SUBJECT: STAFF RESPONSE TO WILLIAM H. WARD'S LETTER ON
SEISMIC ISSUES AT WOLF CREEK

STAFF RESPONSE TO WILLIAM H. WARD'S LETTER ON
SEISMIC ISSUES AT WOLF CREEK

SUBJECT: SITE SPECIFIC GROUND RESPONSE SPECTRA FOR SEP PLANTS
LOCATED IN THE EASTERN UNITED STATES

Figure 10

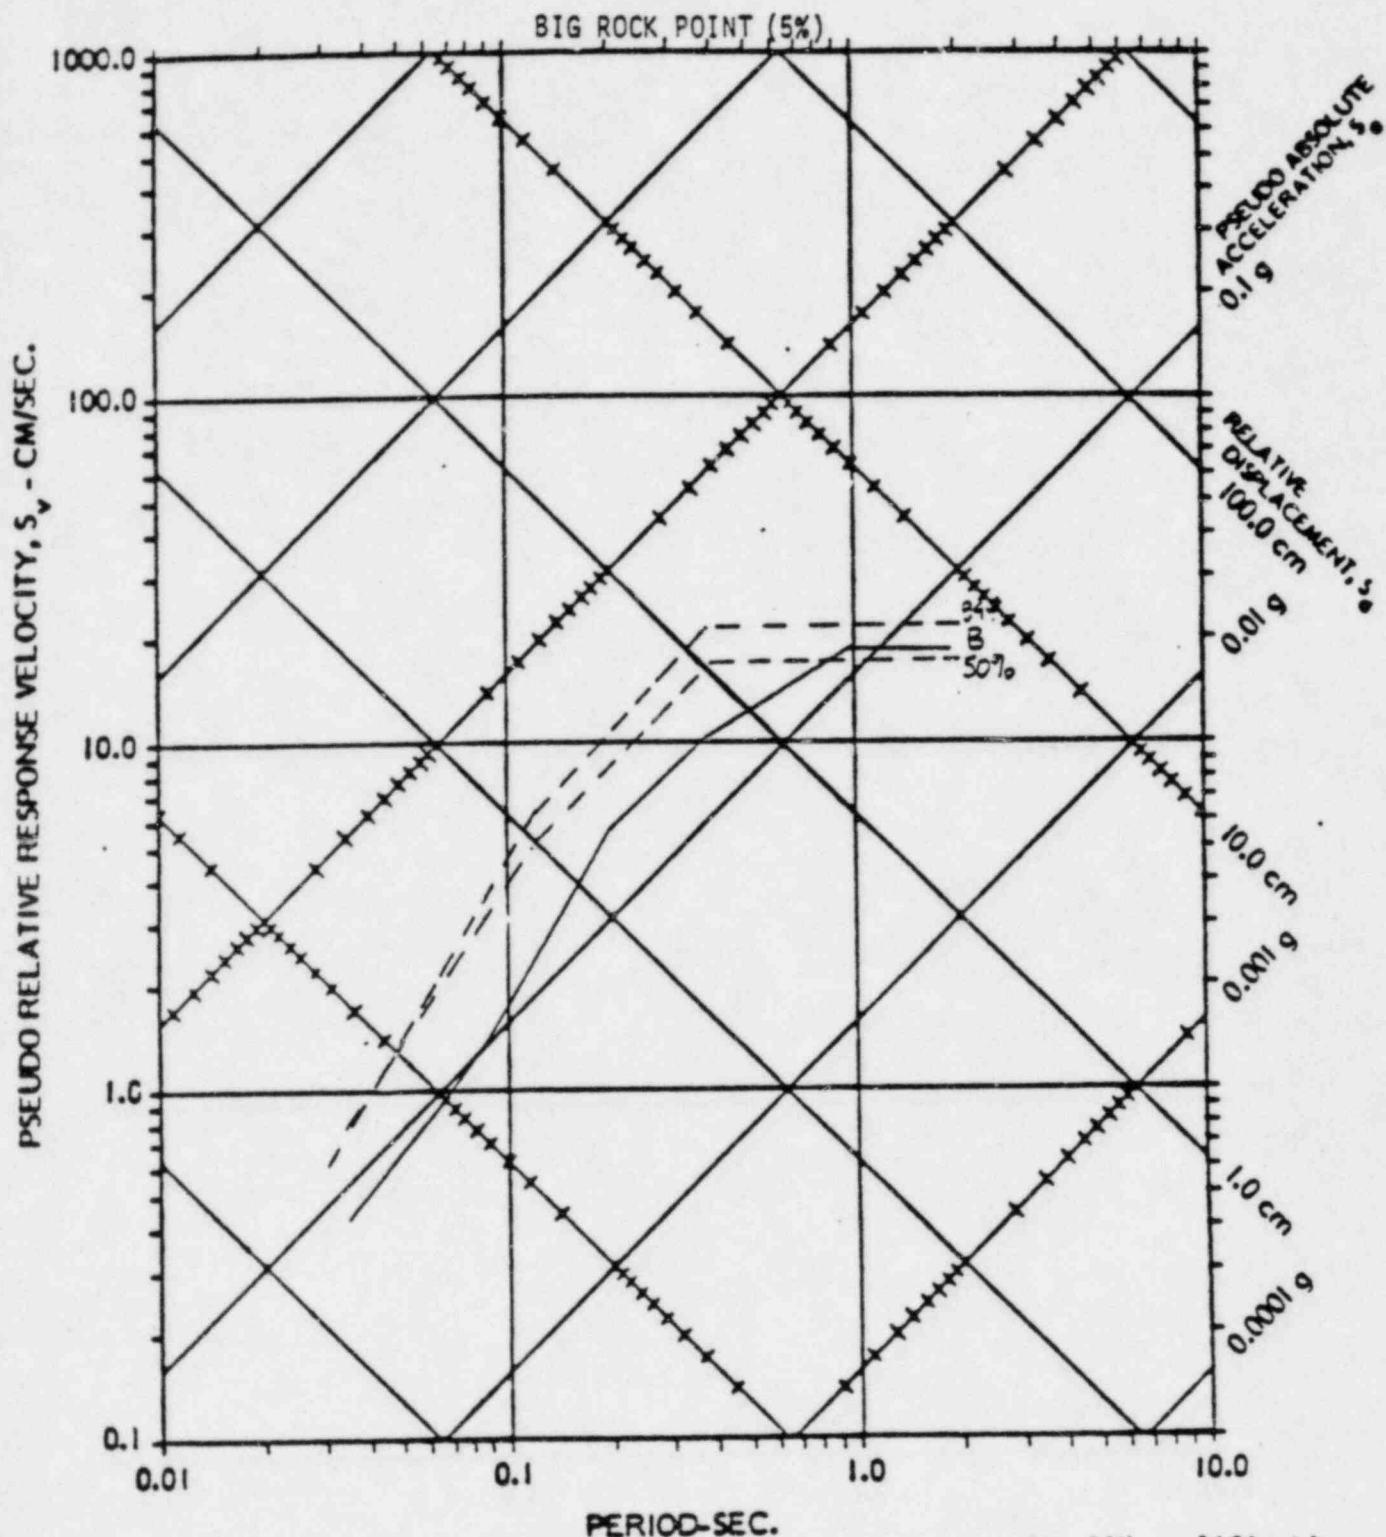
The deterministic peak accelerations and velocities are converted to response spectra using the amplification factors suggested by Newmark and Hall in NUREG CR-0098. Figs. 3 thru 11 compare the recommended uniform hazard spectra with 50th and 84th percentile deterministic spectra. In the central U.S. the recommended spectra generally fall below or at the 50th percentile. In the eastern United States the uniform hazard spectra are approximately

equivalent to the 84th percentile deterministic spectra. While the deterministic peaks are generally lower than the predicted peaks, use of the 84th percentile amplification factors usually more than compensate for the differences. Again the uniform hazard spectra more adequately reflect perceived relative hazard. The "tectonic province" approach can be made to achieve conservatism in this case by utilizing conservative amplification factors. Figures 12 and 13 show the uniform spectra compared to Reg. Guide 1.60 spectra anchored at 0.1 and 0.2g. Following suggested Standard Review Plan procedures for new plants that is utilizing the trend of the means of Trifunac and Brady (1975) to anchor the Reg. Guide 1.60 spectra, would result in design spectra anchored at between 0.12 and 0.20g. The specific acceleration used would depend in large part upon the applicants submittal and the reviewer's conservatism. For the central U. S. the recommended spectra are mostly below the Reg. Guide spectrum anchored at 0.1g while for eastern U. S. the recommended spectra are at or above the Reg. Guide spectrum anchored at 0.1g. The average recommended spectrum would be roughly equivalent to the Reg. Guide 1.60 Spectrum anchored at a peak acceleration of about 0.1g. The observation that the average peak acceleration associated with the recommended spectra (Table 2) is about 0.15g illustrates the often discussed conservatism of the Reg. Guide spectrum. It was conservatively derived from earthquakes of different sizes recorded at different distances and different site conditions.

Figure 12

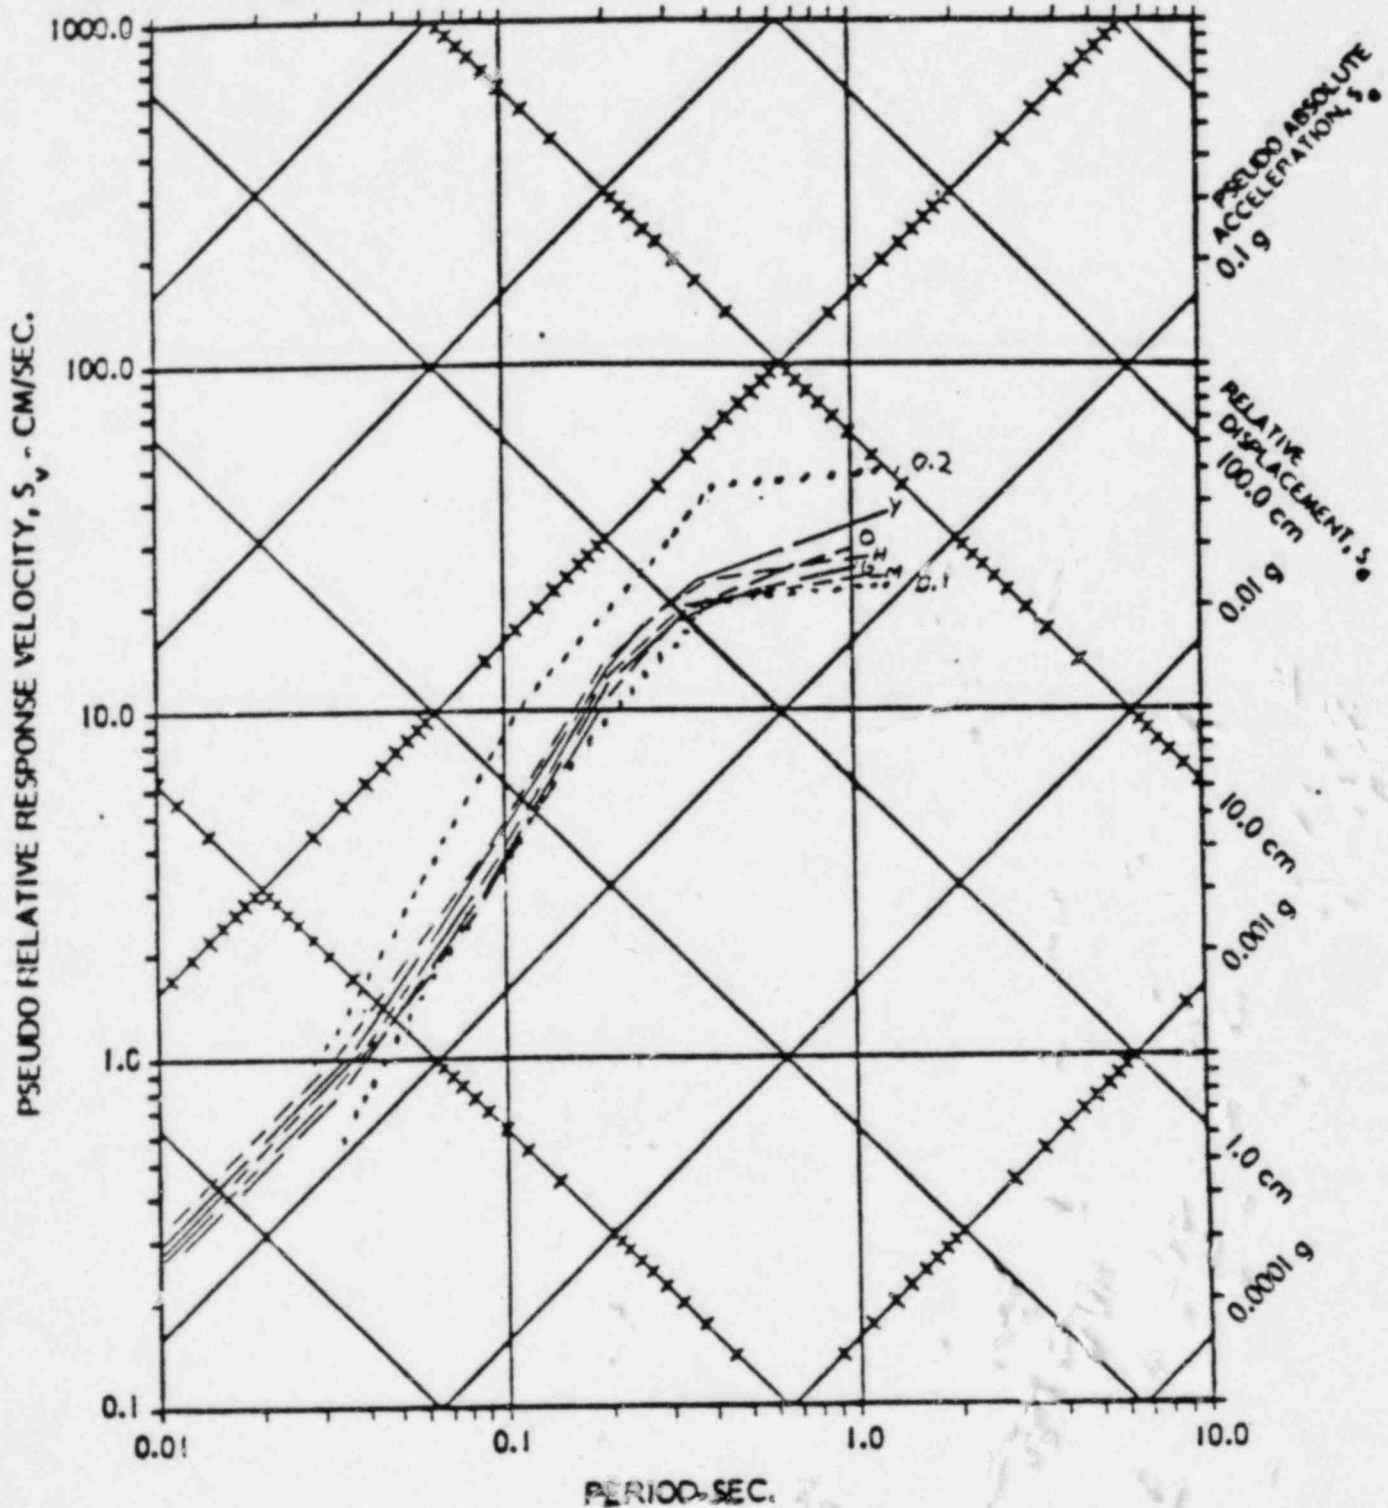
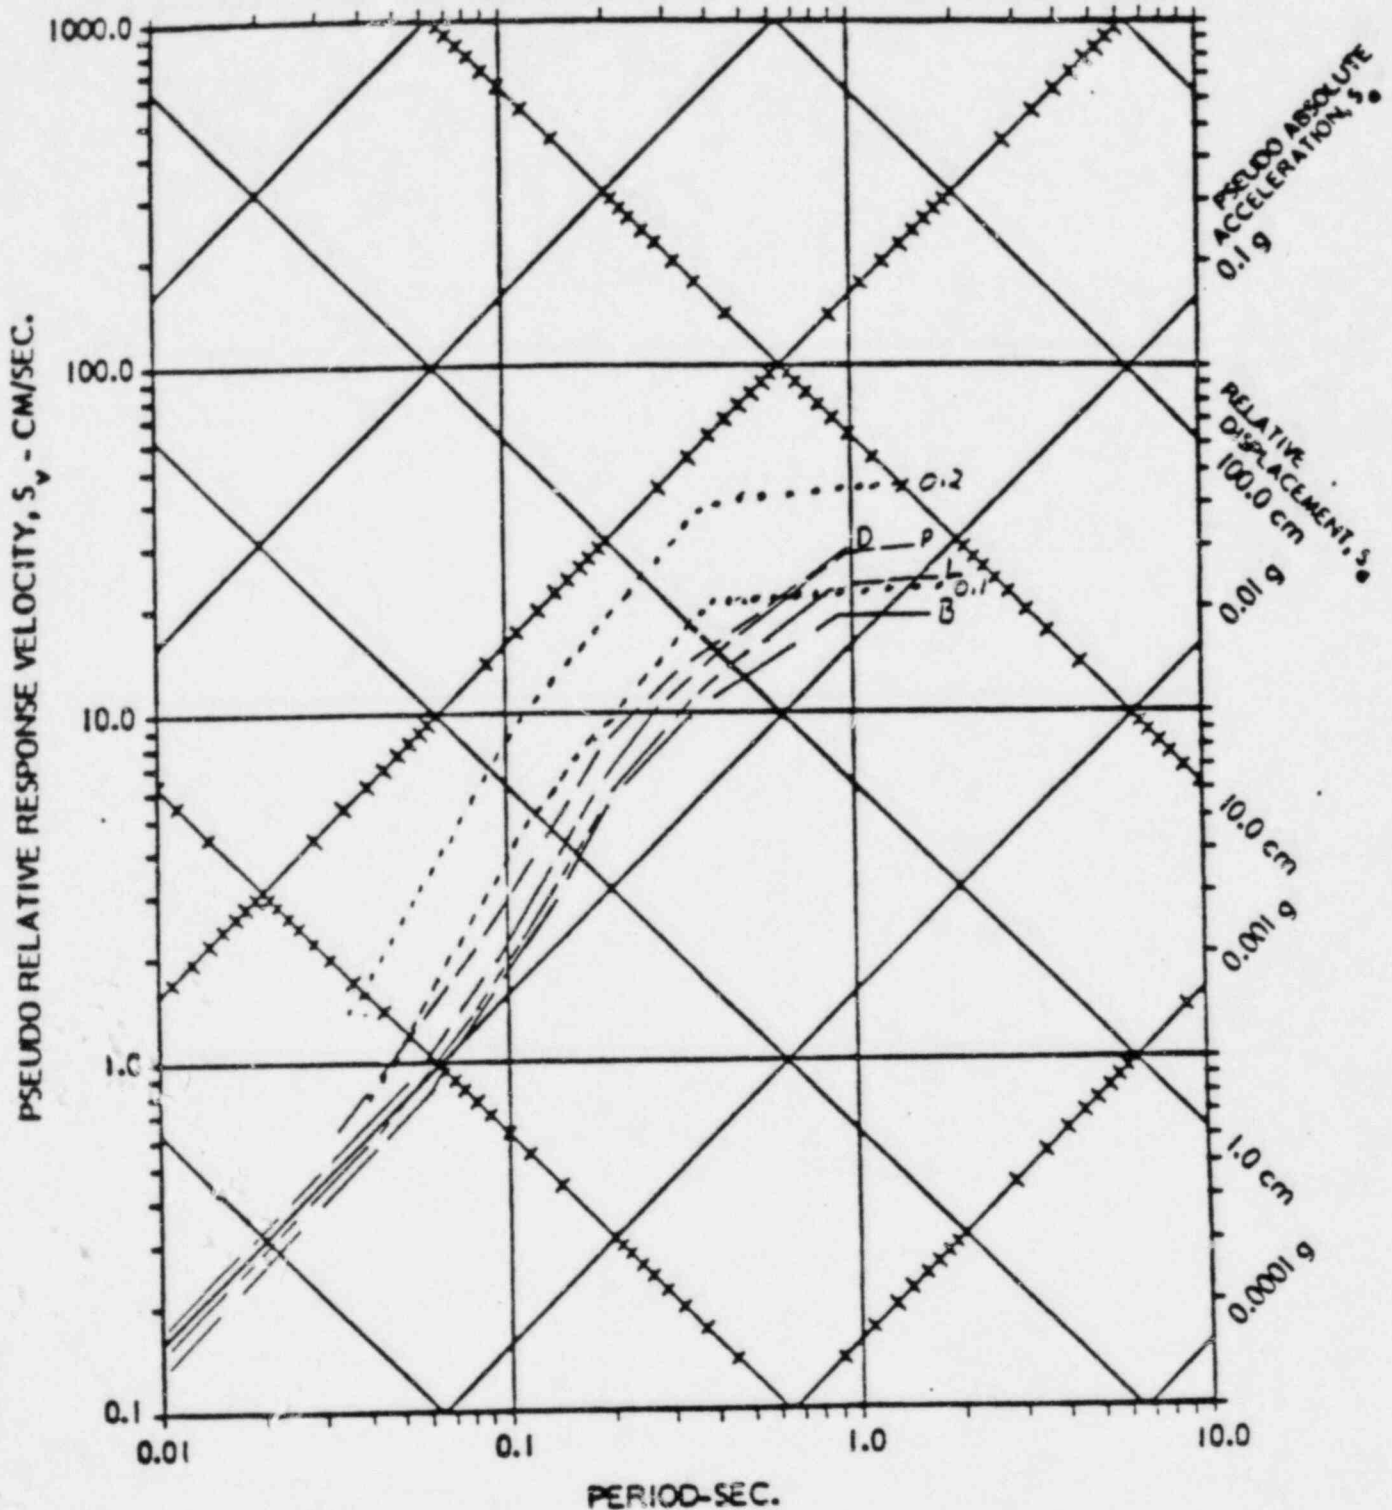
Figures 12 and 13 show the uniform spectra compared to Reg. Guide 1.60 spectra anchored at 0.1 and 0.2g. Following suggested Standard Review Plan procedures for new plants that is utilizing the trend of the means of Trifunac and Brady (1975) to anchor the Reg. Guide 1.60 spectra, would result in design spectra anchored at between 0.12 and 0.20g. The specific acceleration used would depend in large part upon the applicants submittal and the reviewer's conservatism. For the central U. S. the recommended spectra are mostly below the Reg. Guide spectrum anchored at 0.1g while for eastern U. S. the recommended spectra are at or above the Reg. Guide spectrum anchored at 0.1g. The average recommended spectrum would be roughly equivalent to the Reg. Guide 1.60 Spectrum anchored at a peak acceleration of about 0.1g. The observation that the average peak acceleration associated with the recommended spectra (Table 2) is about 0.15g illustrates the often discussed conservatism of the Reg. Guide spectrum. It was conservatively derived from earthquakes of different sizes recorded at different distances and different site conditions.

Figure 14

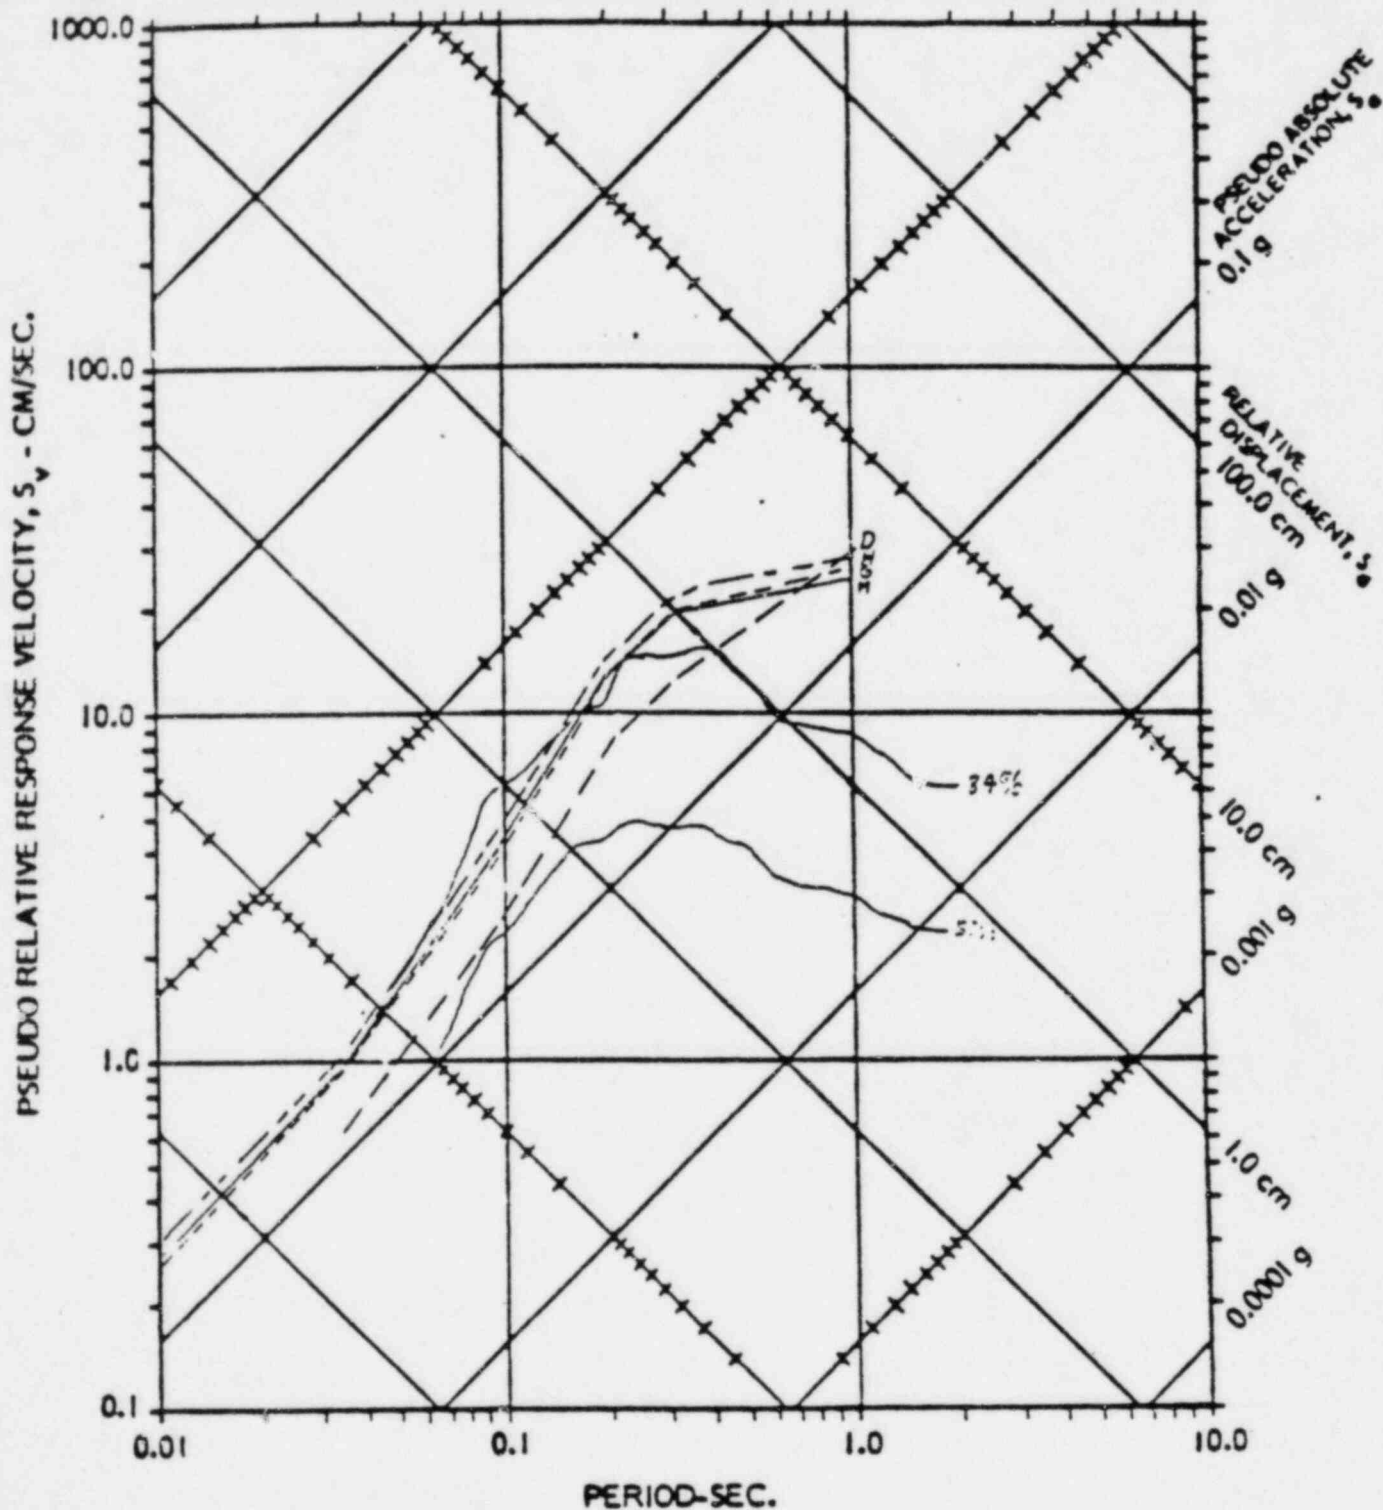
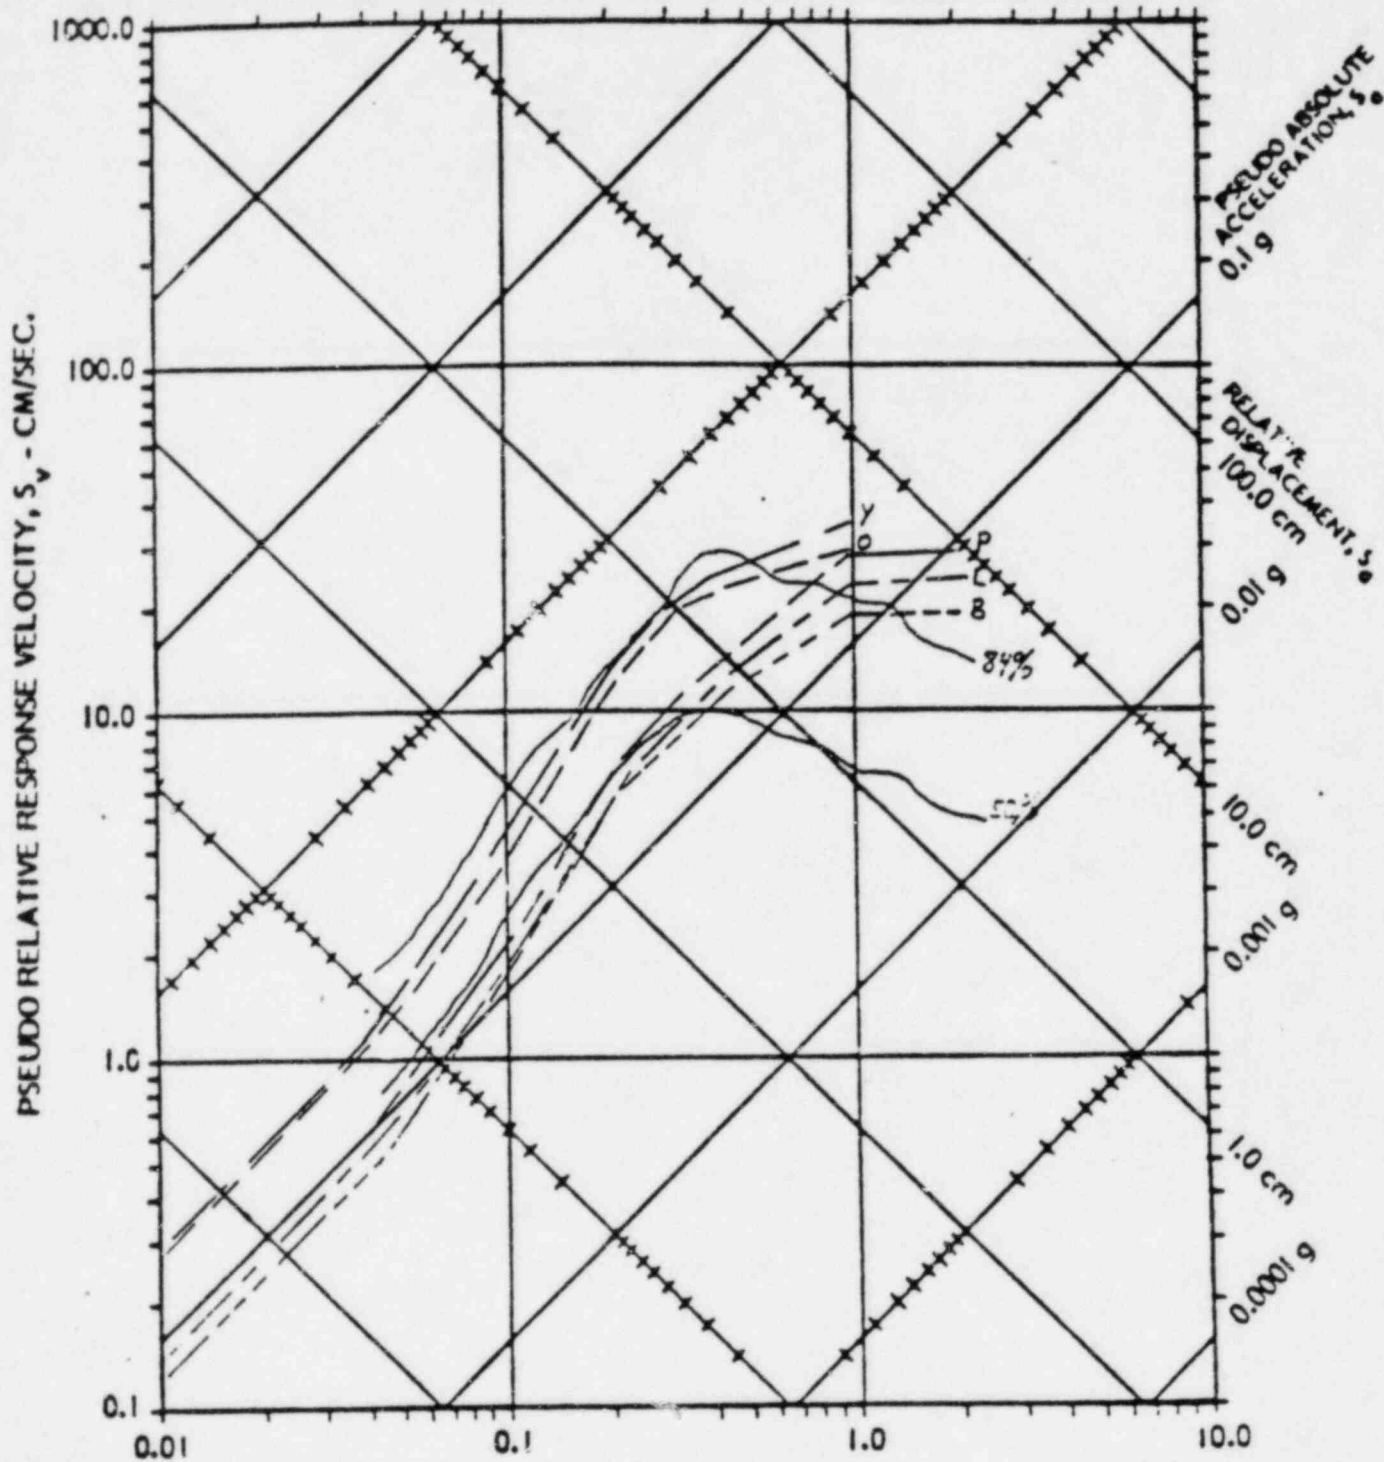
A more applicable comparison can be found in Figures 14 and 15. Here the recommended spectra are compared to the 50th and 84th Percentile levels of ensembles of response spectra derived from strong motion records recorded at nearby distances (usually 27 km or less) from earthquakes of magnitude
